Administrative Authorization Application

PROJECT NAME: AT&T MOBILITY WIRELESS NEW SITE INSTALLATION

PROJECT ADDRESS: 25 Pearl Street **CHART/BLOCK/LOT:** 029 E009001

**Prepared For:
AT&T Mobility
Site No.: ME2976
Site Name:
CUSTOM HOUSE GARAGE
25 Pearl Street
Portland, ME 04101**

Sound Test Results

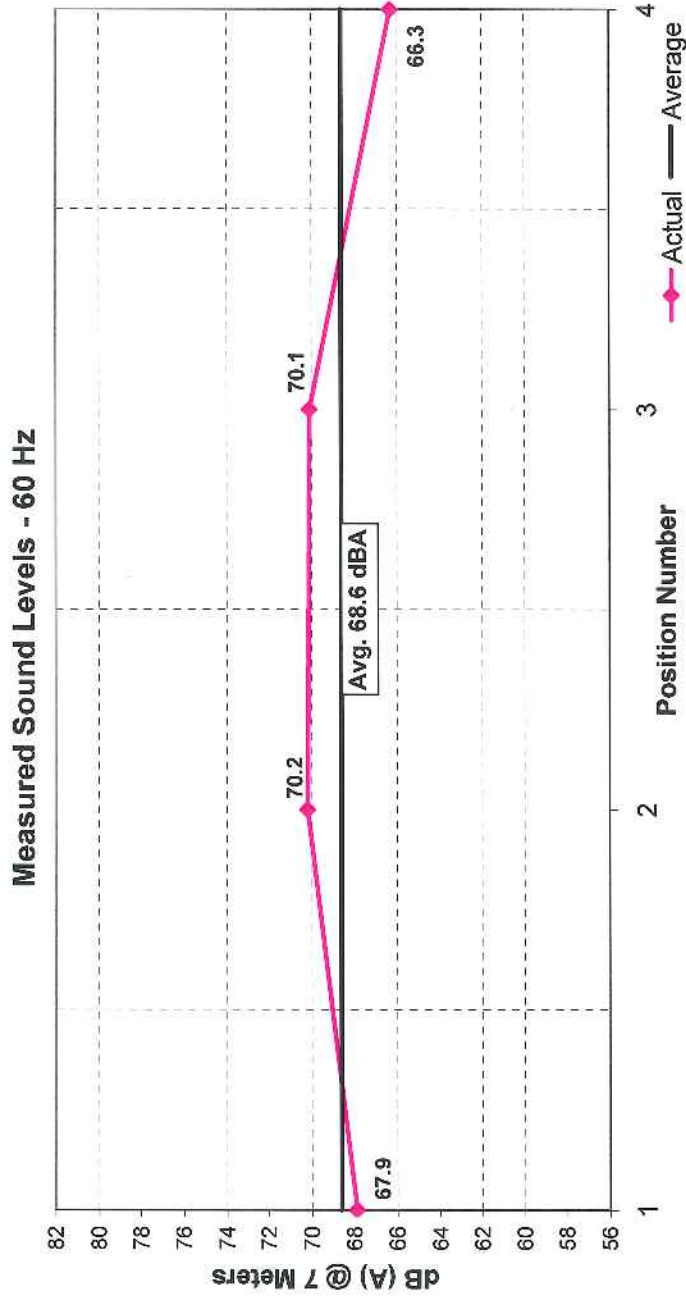
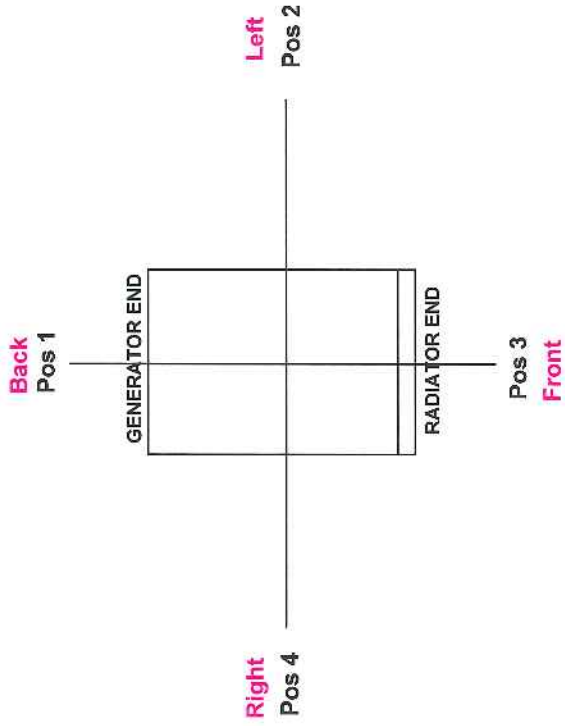
As I understand the proposal, there is a generator proposed. Is there any noise attenuation being proposed for the emergency generator and what are the projected noise levels? Please forward the specifications to me.

Genset specs attached – last page has noise levels. AT&T uses the sound enclosure so 71 dB at 23 feet away.
